**Committee of Experts on the Transport of Dangerous Goods
and on the Globally Harmonized System of Classification
and Labelling of Chemicals****Sub-Committee of Experts on the Transport of Dangerous Goods****Forty-fourth session**

Transport of gases: miscellaneous**Packing instructions P200 and P206 for collective entries****Transmitted by the expert from Germany¹****Background**

Fig. 1: Schematic presentation of the volumetric expansion for the calculation of the internal pressure in pressure receptacles containing liquid phases and compressed gas

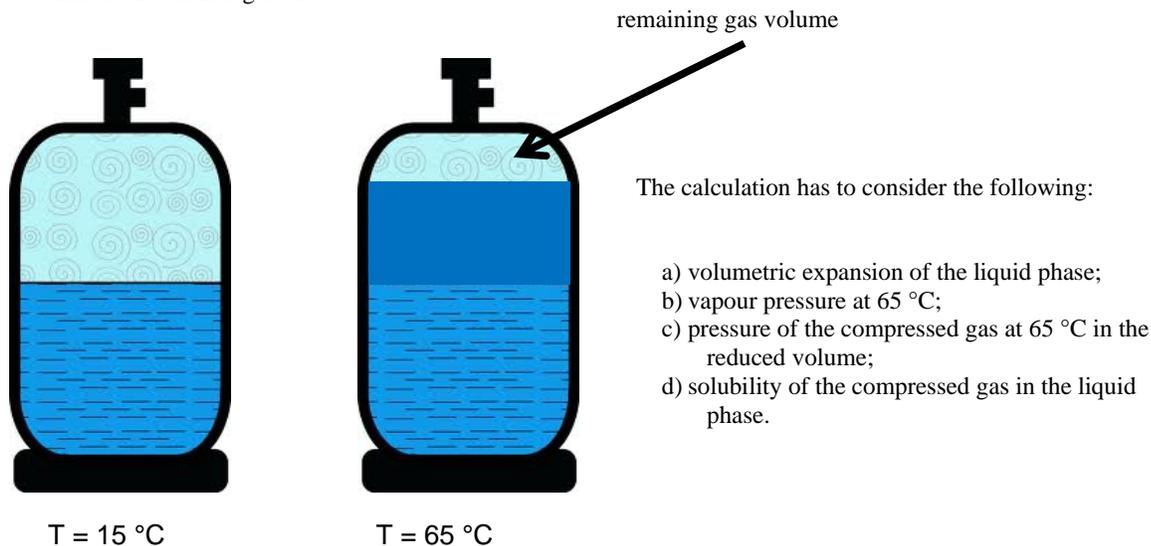
2. For cases where a liquid phase of a fluid is charged with a compressed gas, the above packing instructions do not include instructions on how to calculate the filling ratio and test pressure. In these cases, both components – the liquid phase and the compressed gas – have to be taken into consideration in the calculation of the internal pressure in the pressure receptacle.

This is shown in Figure 1:

3. If only the compressed gas is considered in accordance with P200 (3) (a), this results in calculated pressures which are too low and not acceptable from the point of view of safety. If only the vapour pressure of the liquefied component at 65 °C is considered in accordance with P200 (3) (c) and/or P206 (3), this also result in calculated pressures which are too low and not acceptable from the point of view of safety.
4. A complete calculation formula is not given in P200 and P206. Experimental values are often also not available.
5. A similar approach to calculating test pressures taking into account both the compressed gas and the liquid phase for tanks is given under 6.7.2.1 and 6.7.3.1.

“(e) For pressure liquefied gases or liquids charged with compressed gases, the maximum mass of contents per litre of water capacity shall equal 0.95 times the density of the liquid phase at 50 °C; in addition, the liquid phase shall not fill the pressure receptacle at any temperature up to 60 °C.

When full, the internal pressure at 65 °C shall not exceed the test pressure of the pressure receptacles. The vapour pressures and volumetric expansions of all substances in the pressure receptacles shall be considered. The following steps shall be carried out:

- a. Calculation of the vapour pressure of the liquid component and of the partial pressure of the compressed gas at 15 °C (filling temperature);
- b. Calculation of the volumetric expansion of the liquid phase resulting from the heating from 15 °C to 65 °C and calculation of the remaining volume for the gaseous phase;

- c. Calculation of the partial pressure of the compressed gas at 65 °C considering the volumetric expansion of the liquid phase;
- d. Calculation of the vapour pressure of the liquid component at 65 °C;
- e. The total pressure is the sum of the vapour pressure of the liquid component and the partial pressure of the compressed gas at 65 °C;
- f. Consideration of the solubility of the compressed gas at 65 °C in the liquid phase;

The test pressure of the pressure receptacle shall be not less than the calculated pressure minus 100 kPa (1bar).
